**78-90 OLD CANTERNBURY ROAD, LEWISHAM
SECTION 75W – AMENDMENT TO CONDITIONS 11 OF CONCEPT APPROVAL MP08-0195)**

In accordance with Section 75W of the Environmental Planning and Assessment Act 1979 (as amended from time to time), a modification is sought to amend Condition 11 of MP08-195 ("Concept Approval") to allow for the inclusion of "through site links" and "drainage reserves" as part of the approved Central Open Space.

LEWISHAM ESTATE DRAINAGE WORKS

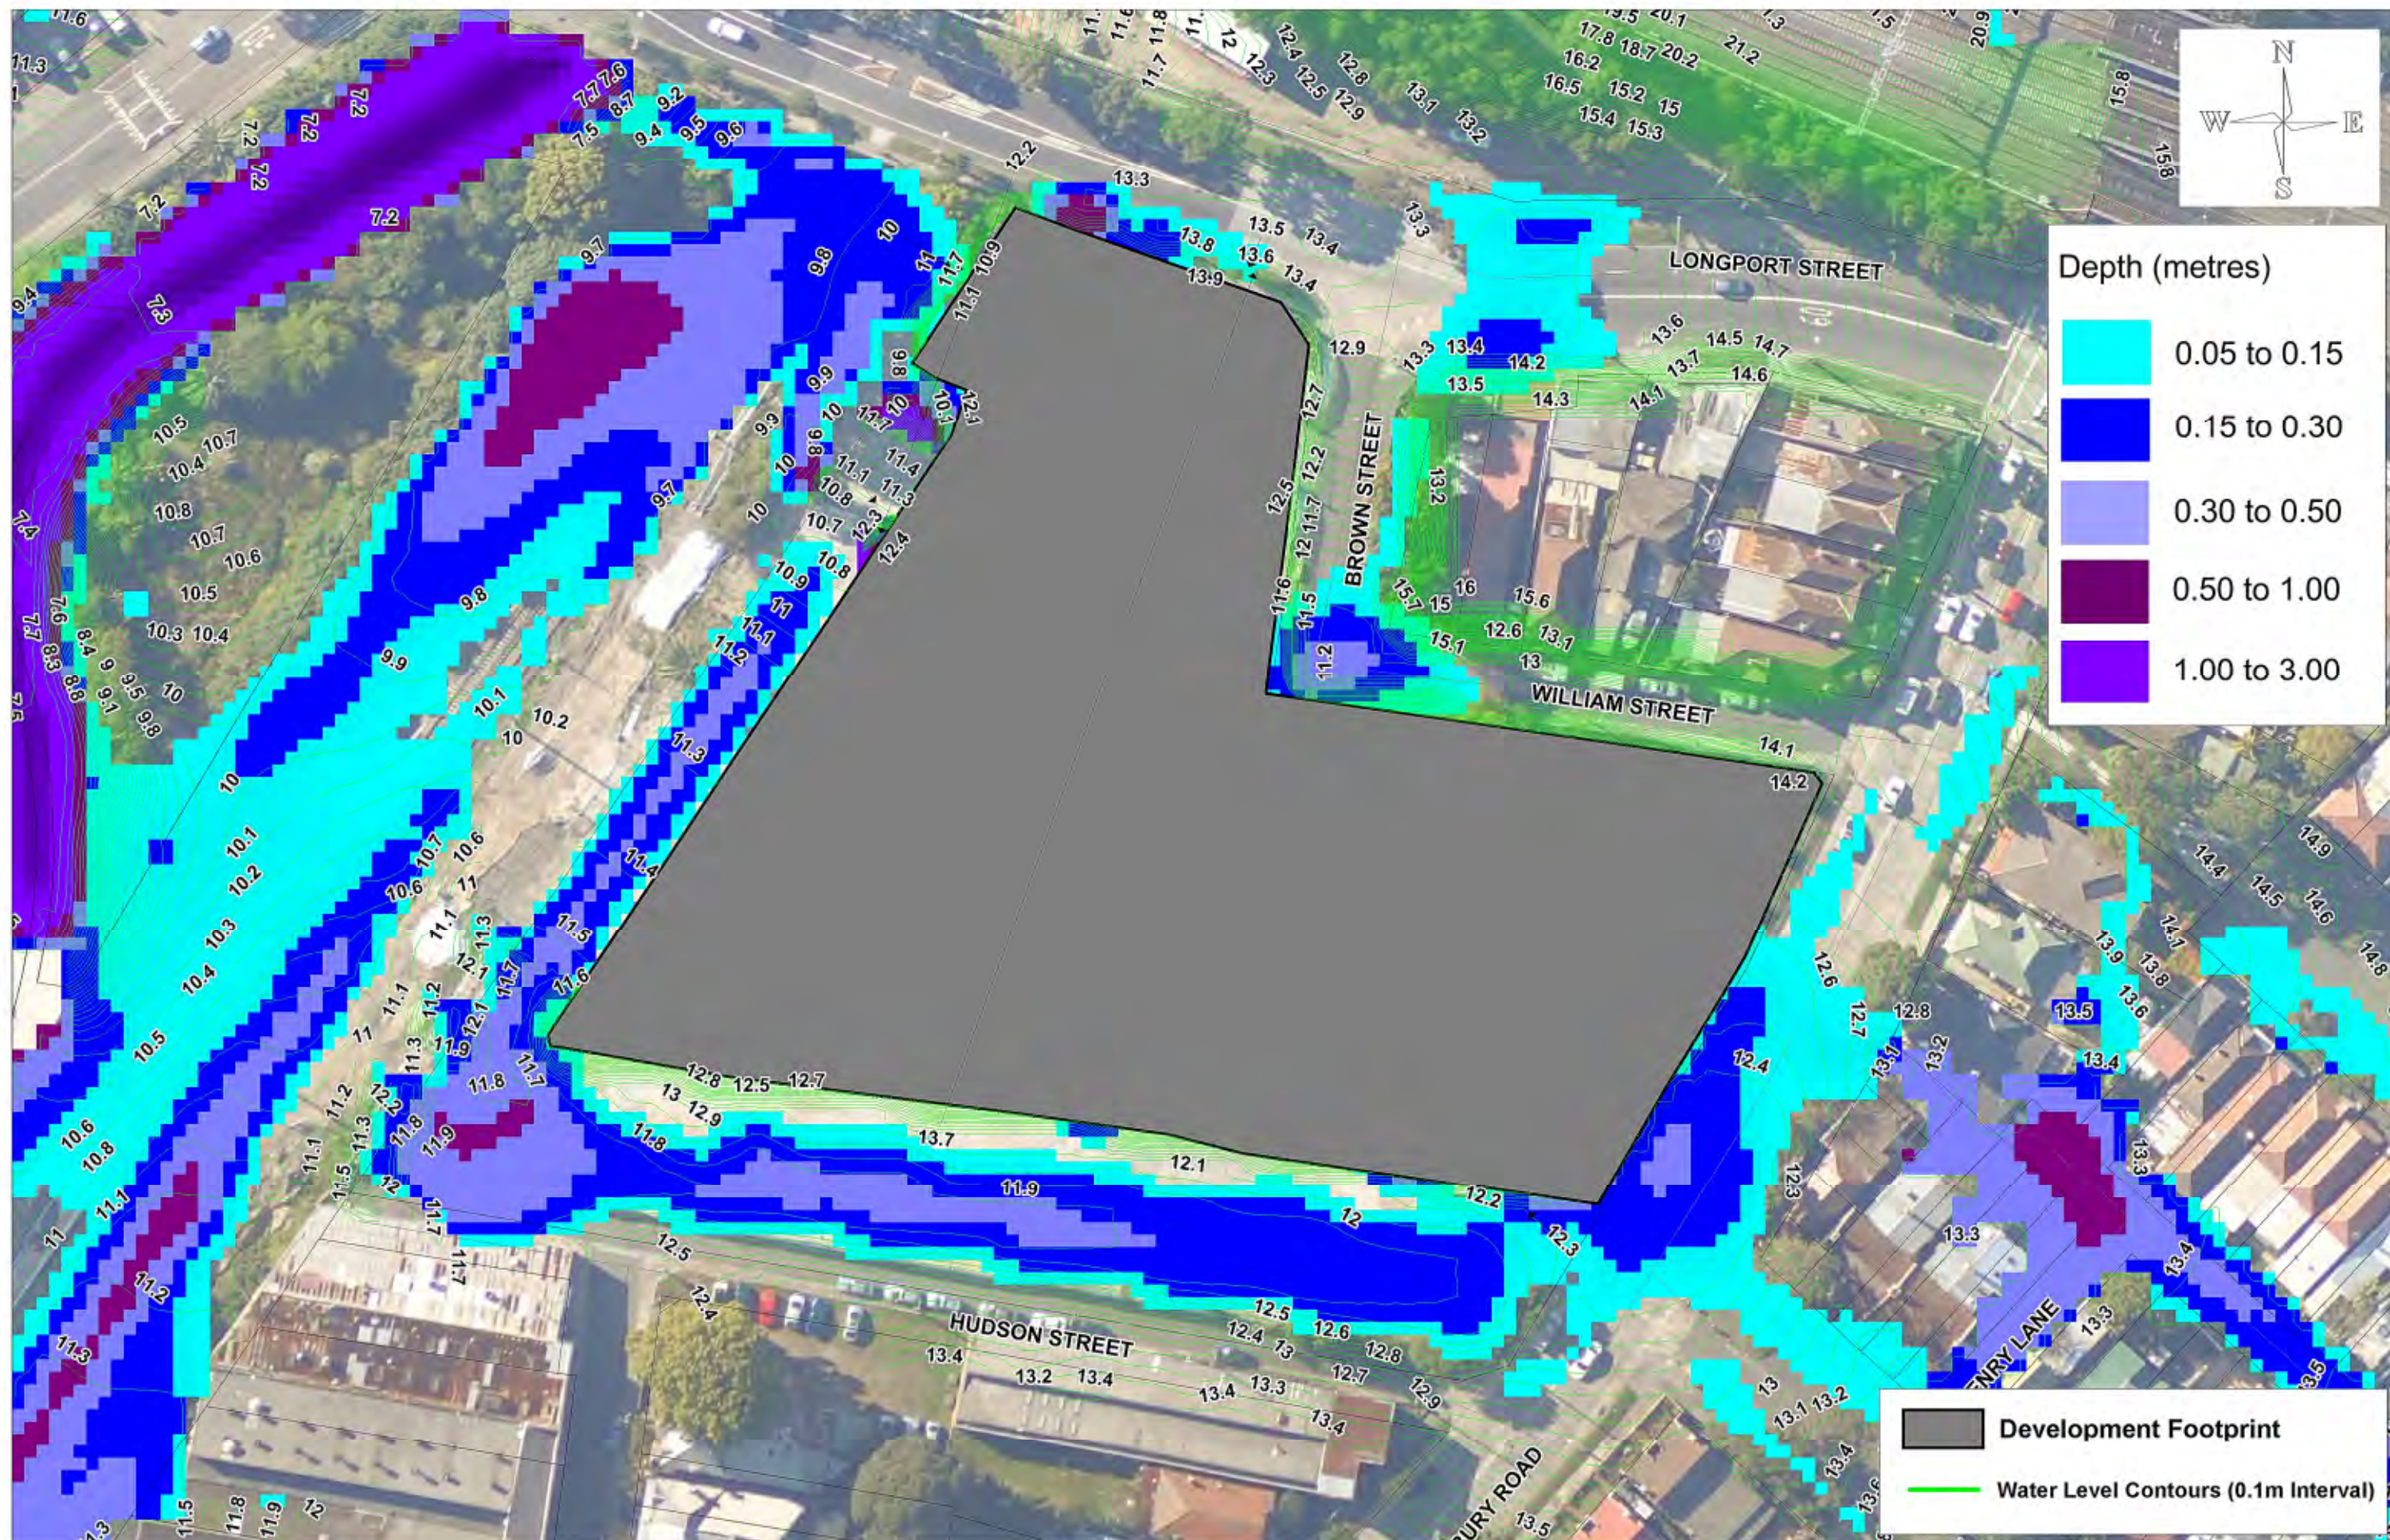
- While **Figure B9** shows some local increases in peak flood levels within the Light Rail corridor at the end of Hudson Street this appears to be associated with the representation of the flood wall in the model and will be adjusted in future modelling.
